April 7, 2005  
Job No. 3-817-004355

Re: Discussions  
Geotechnical Considerations  
Proposed Cottonwood Heights Branch  
Mountain America Credit Union  
Approximately 6400 South on the  
East Side of 3000 East Street  
Cottonwood Heights, Utah

This letter summarizes our review of the Site Grading drawings developed for the referenced facility<sup>1</sup>. In addition discussions pertaining to the overall geotechnical setting of the site are summarized. Detailed geotechnical recommendations for the design and construction for the facility were presented previously. A summary memorandum developed for the building site and a similar structure ultimately submitted to the owner is attached. It should be noted that the original design concept included a subgrade level below a portion of the footprint. It is our understanding that the present concept will have the first level established at grade.

Check Sections  
Credly U

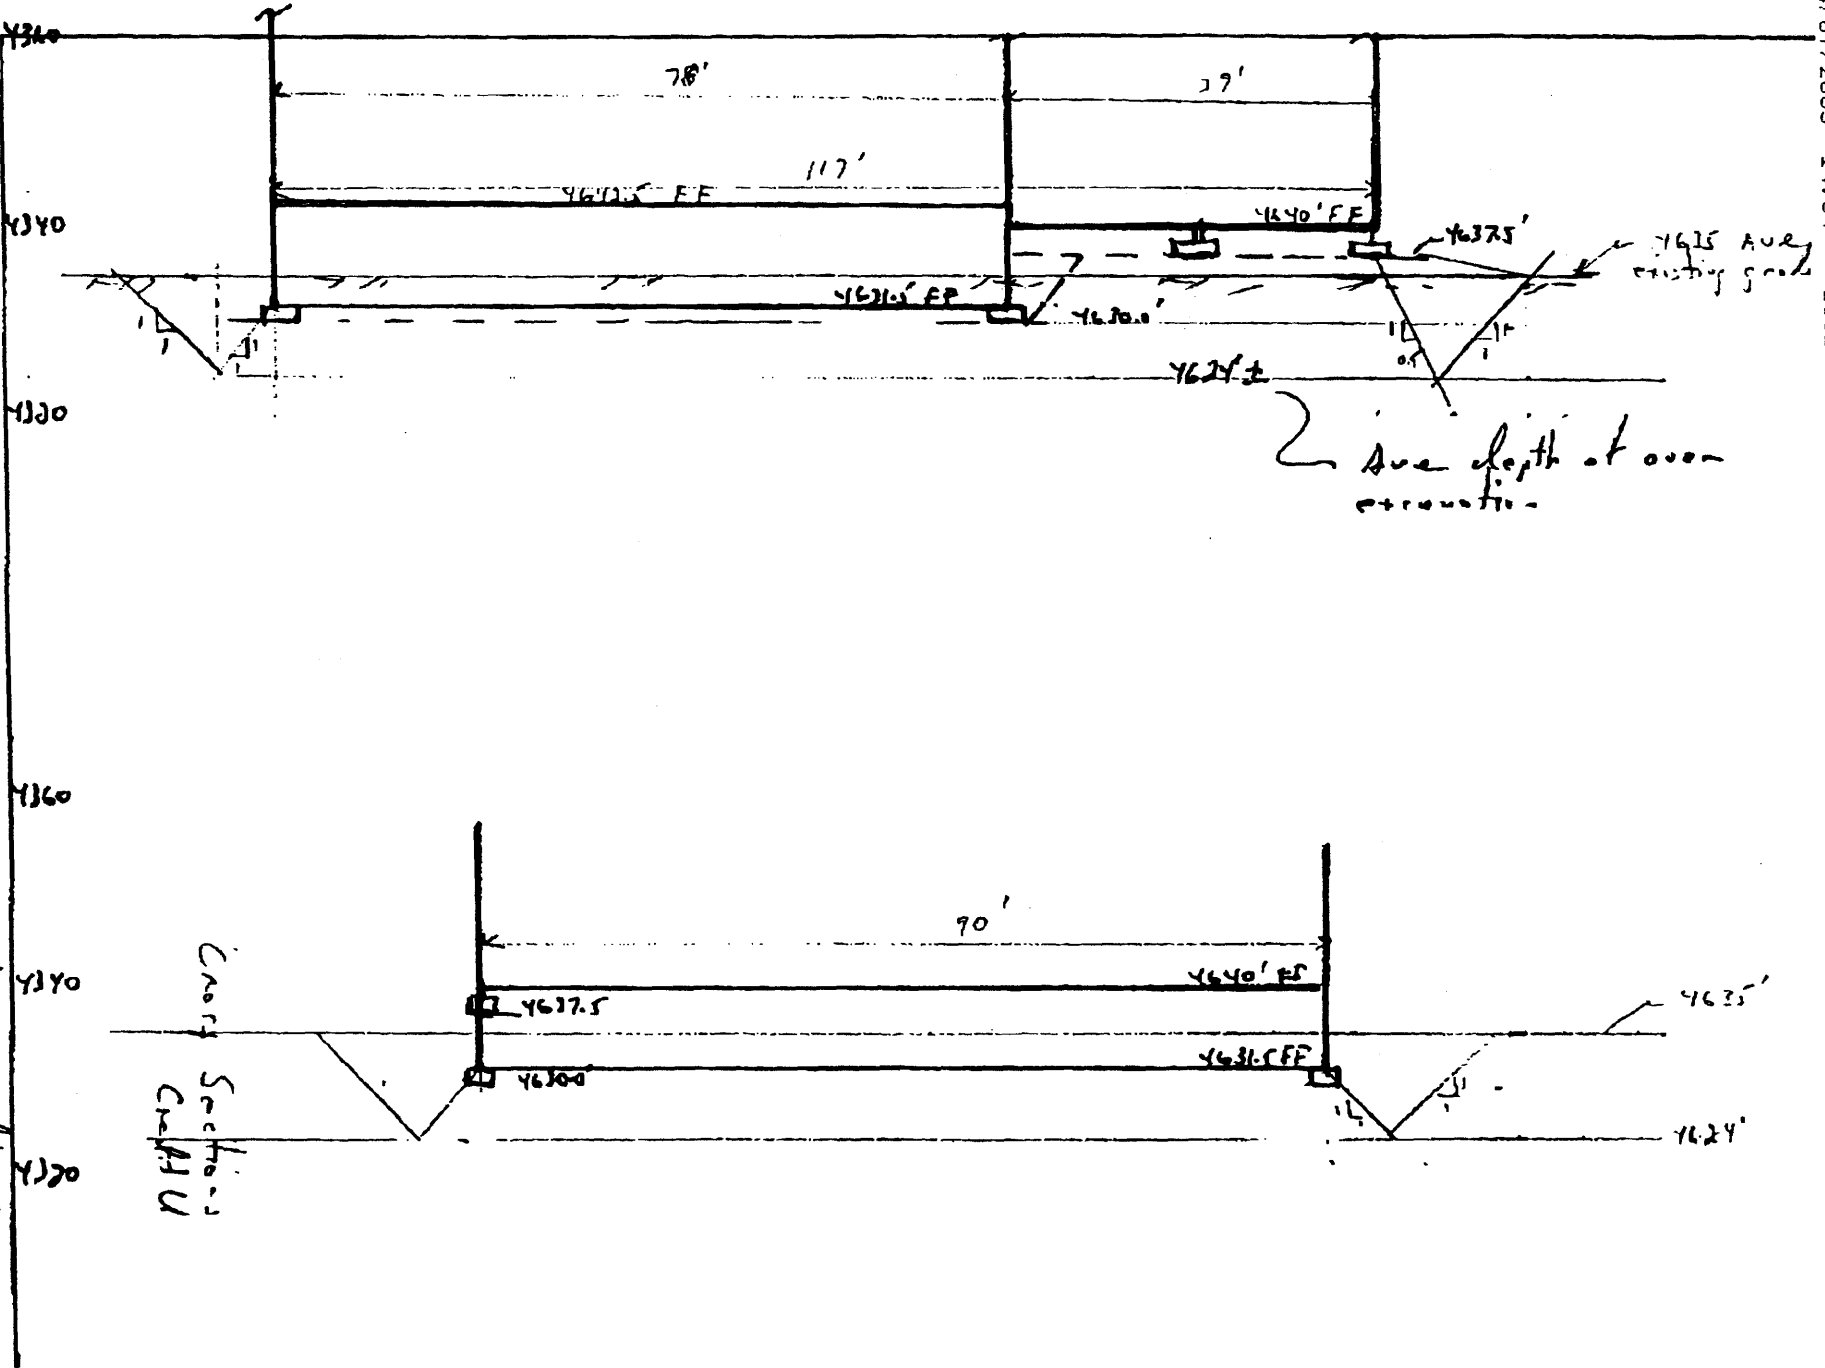
Strip all existing fills out from an area extending 6' beyond perimeter of the building. This includes work out fines and general nonengineered fills. Ave depth of excavation will be 11' ±

Backfill back to 4620' beneath basement & 4637.5' beneath drive under. This will bring fill to projected footing elevation.

Backfill to 4627.5' Beneath Drive Under
